Comment Resolution for Clause 162 Topics

Howard Heck, Intel
Chris Diminico, xxx

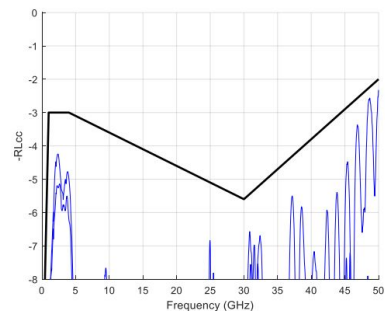
CI 162 SC 162.9.4.6 P 172 L 47 # R1-48
 Dawe, Piers J G NVIDIA
 Comment Type TR Comment Status D TX RLcc

As already noted, this common mode return loss spec RLcc becomes useless at the frequency when the HCB loss is 2/2 dB, which is only 7.5 GHz. The spec should trend down somewhat slower than twice the MCB trace loss, at 0.1 dB/GHz.

Use a frequency-dependent mask: 2 dB $0.2 \leq f \leq 4$, $1.6+0.1*f$ dB $4 < f \leq 30$, $8.5-0.13f$ $30 < f \leq 40$. f is in GHz. See another comment for cable RLcc, 162.11.6.

PROPOSED REJECT.

The following related presentation was provided for review by the task force:
https://www.ieee802.org/3/ck/public/22_04/dawe_3ck_01_0422.pdf
 The suggested remedy does not provide evidence to support the suggested remedy.
